Access Compliance Report

Public Rights-of-Way (Curb Ramps)

Intersection ID: N/A	Main Street: ARDREY_KELL_RD	Cross Street: PROVIDENCE_ROW_LN	Location: SE
ADA ID: 18ED46834F51	Ramp Type: PerpDiag	Initial Pass/Fail: Fail	Overall Compliance: No
		Severity Score: 12.5

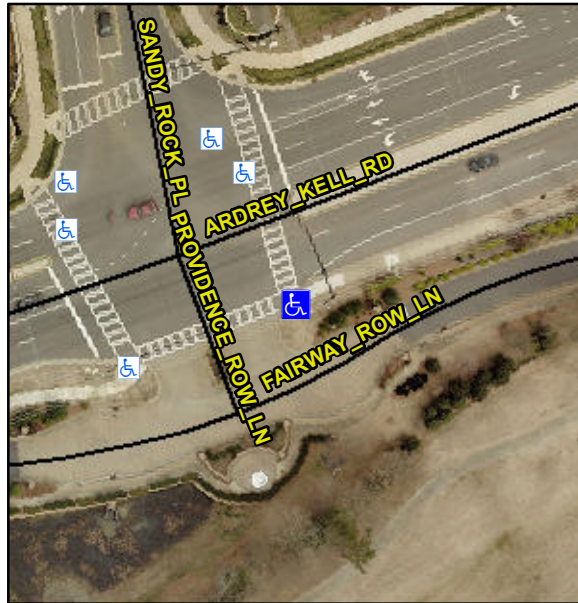
Not Found, R304.5.3

Compliance	Description	Data	Compliance	Description	Data
N/A	Ramp Length (in)	24.0	Yes	Ramp Slope (%)	5.5
Yes	Ramp Width (in)	48.0	No	Ramp XSlope (%)	5.3
N/A	Flare Type LT	N/A	N/A	Flare Type RT	N/A
N/A	Flare Slope LT (%)	N/A	N/A	Flare Slope RT (%)	N/A
N/A	Flare Traversable LT?	N/A	N/A	Flare Traversable RT?	N/A
N/A	Landing Length (in)	N/A	N/A	DWS Provided?	N/A
N/A	Landing Width (in)	N/A	N/A	DWS Contrast?	N/A
N/A	Landing Slope (%)	N/A	N/A	DWS Length (in)	N/A
N/A	Landing X Slope (%)	N/A	N/A	DWS Full Width?	N/A
N/A	Landing Curb? (Y/N)	N/A	N/A	DWS Offset (in)	N/A
N/A	Shared Landing?	N/A			
N/A	Gutter Ponding?	N/A	N/A	Gutter Slope (%)	N/A
N/A	Gutter Lip Ht (in)	N/A	N/A	Gutter X Slope (%)	N/A
N/A	Painted X Walk1?	Yes	N/A	Painted X Walk2?	Yes
	X Walk 1 Direction	To N		X Walk 2 Direction	To W
N/A	X Walk 1 Width (in)	112.0	N/A	X Walk 2 Width (in)	86.0
	X Walk 1 Slope (%)	6.0		X Walk 2 Slope (%)	0.8
	X Walk 1 X Slope (%)	2.5		X Walk 2 X Slope (%)	8.9

N/A	Ramp inside XWalk1?	Yes	N/A	Ramp inside XWalk2?	Yes
	Road Slope (%)	6.3	N/A	Clear Space?	N/A
	Road X Slope (%)	6.0	N/A	Clear Space to XWalk (in)	N/A
N/A	Any Obstructions?	N/A	N/A	Storm Grate/Utility Hazard?	N/A
	Obstruction Type			Storm Grate/Utility Type	
		N/A			N/A
		Yes		Surface Condition? (G/P)	Good

Remove & Replace Curb Ramp With Two New Directional Ramps or Equivalent.
